الموضوع: إشعار بمتابعة جهاز طبي

Therapy, traction equipment. YUNO extension device

**RECALL**  
**IMPORTANT CUSTOMER NOTIFICATION**  
**PRODUCT CORRECTION**

The purpose of this recall is to correct Extension Devices that contain a gap in the handle that could lead to pinching or cutting of the operators' hand during use.

Figure 1: Extension device 1433.62A1 / 1433.62A0

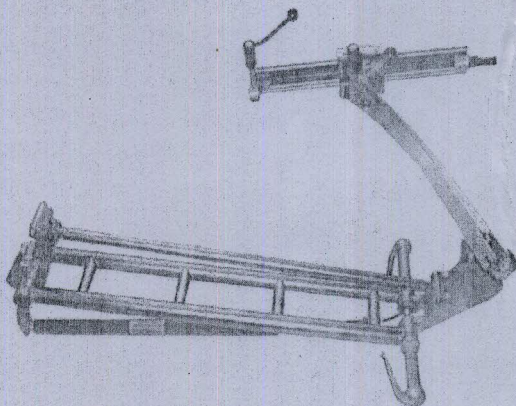
As a result of customer feedback, MAQUET conducted an investigation and identified a potential issue with the handle of the extension device 1433.62A1 and 1433.62A0 (See figure 1) used with the YUNO table.
